ENVIRONMENTAL BOARD MEETING MINUTES Wednesday, August 6, 2008

**ENVIRONMENTAL BOARD REGULAR MEETING MINUTES WEDNESDAY,
August 6, 2008**

SUBJECT: Wildflower Commons PUD - C814-06-0233
4700 – 5200 Blocks of State Highway 45

**Map 1: Location Map for Critical Environmental Feature Setbacks
(Revised - 07-07-2008)**

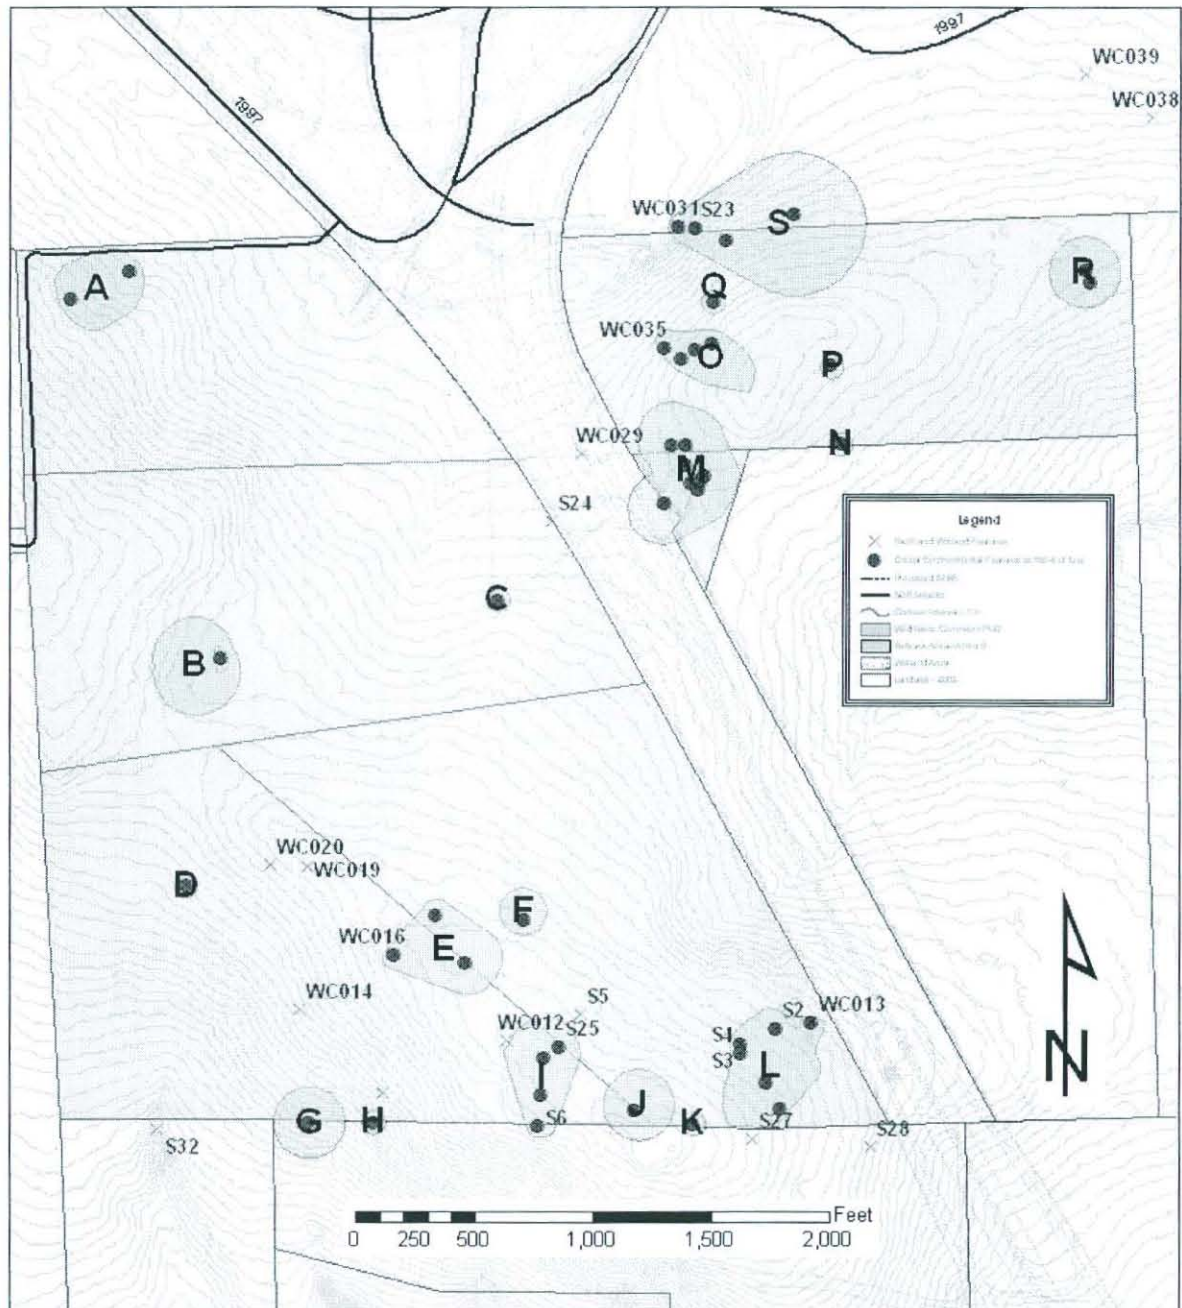
1. No residential lots may include a CEF or be located within 50 feet of a CEF.
2. Setback areas must be established to protect all CEFs. Although the LDC allows a portion of the CEF buffer to be included in a residential lot, I do not recommend that this be allowed. Residential lots should not include any portion of a CEF buffer. Setbacks must comply with the setback area has stated in Table 1 and shown Map 1. ERM is willing to revise setback areas listed in Table 1 and shown on Map 1 during PUD process, if the applicant provides more detail

2. All CEFs and associated CEF buffers are to be shown on all plats, preliminary plans, site plans and construction plans. The PUD ordinance and the plat notes must have a following statement "all activities within the critical environmental feature setback must comply with Section 25-8-281(c)(2) of Austin's Land Development Code. This section states that the natural vegetative cover must be retained to the maximum extent practicable; construction is prohibited; and wastewater disposal or irrigation is prohibited this requirement."

5. Fencing at the edge of CEF buffers must be installed prior to the initiation of construction.
6. Water quality BMPs should not drain directly into CEF setback area. Level spreaders or similar structures must be used to overland sheet flow stormwater before it discharges near CEF setback areas. Stormwater irrigation must occur outside the CEF setback areas.

**Map 1: Location Map for Critical Environmental Feature Setbacks
(Revised - 07-07-2008)**

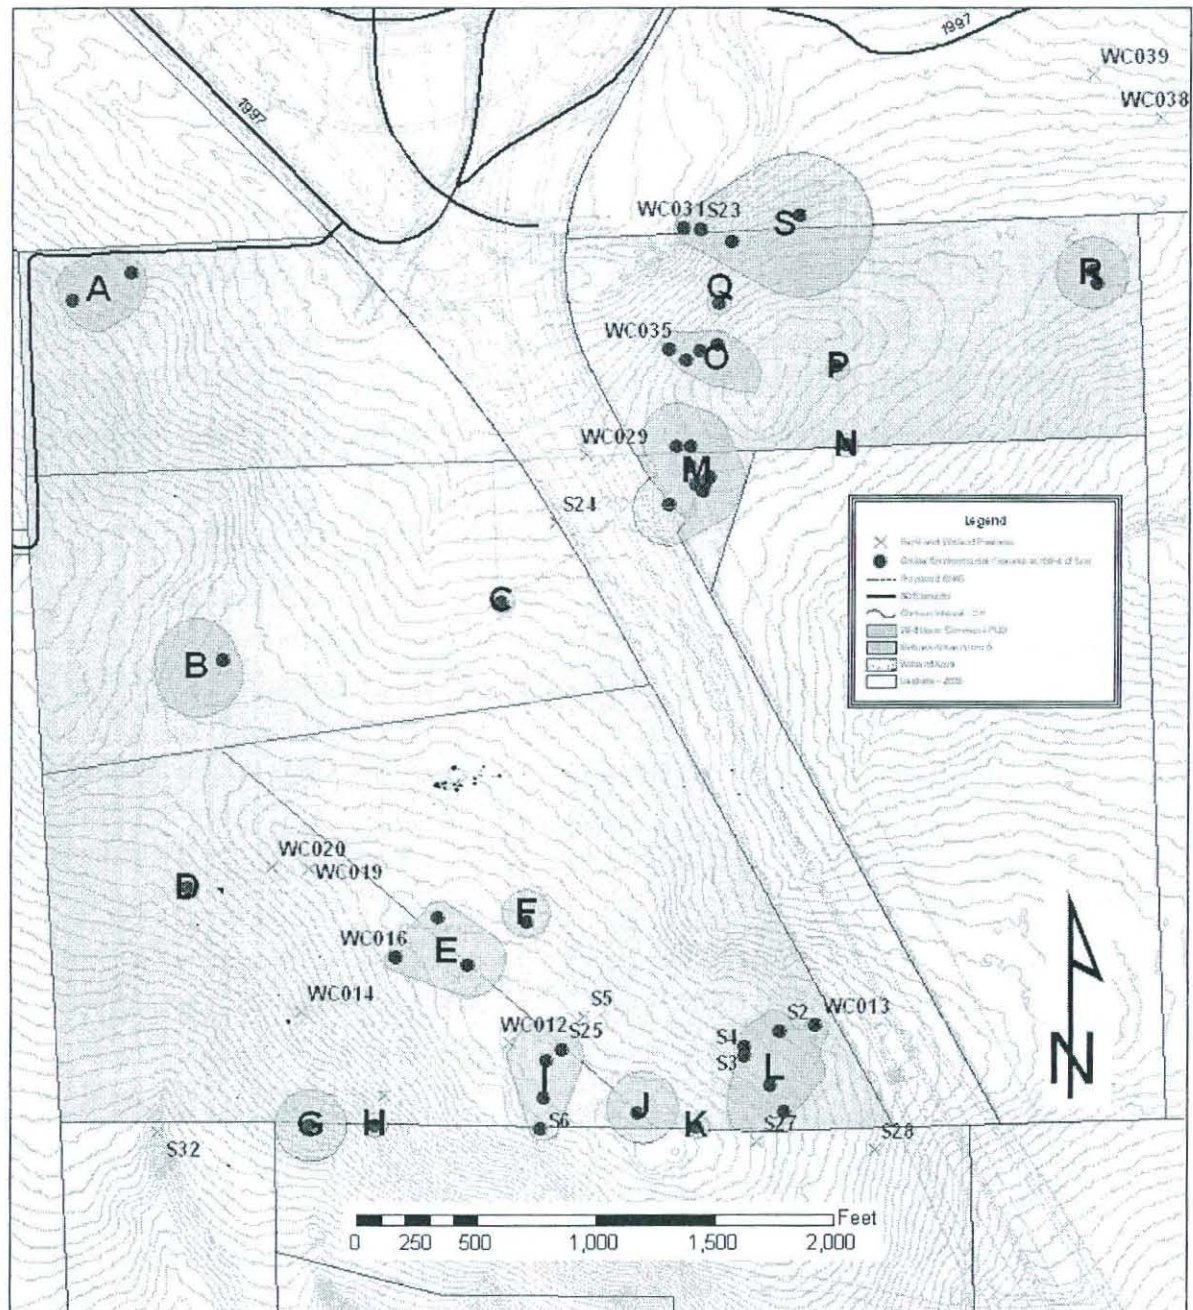
1. No residential lots may include a CEF or be located within 50 feet of a CEF.
2. Setback areas must be established to protect all CEFs. Although the LDC allows a portion of the CEF buffer to be included in a residential lot, I do not recommend that this be allowed. Residential lots should not include any portion of a CEF buffer. Setbacks must comply with the setback area has stated in Table 1 and shown Map 1. ERM is willing to revise setback areas listed in Table 1 and shown on Map 1 during PUD process, if the applicant provides more detail

2. All CEFs and associated CEF buffers are to be shown on all plats, preliminary plans, site plans and construction plans. The PUD ordinance and the plat notes must have a following statement "all activities within the critical environmental feature setback must comply with Section 25-8-281(c)(2) of Austin's Land Development Code. This section states that the natural vegetative cover must be retained to the maximum extent practicable; construction is prohibited; and wastewater disposal or irrigation is prohibited this requirement."

5. Fencing at the edge of CEF buffers must be installed prior to the initiation of construction.
6. Water quality BMPs should not drain directly into CEF setback area. Level spreaders or similar structures must be used to overland sheet flow stormwater before it discharges near CEF setback areas. Stormwater irrigation must occur outside the CEF setback areas.
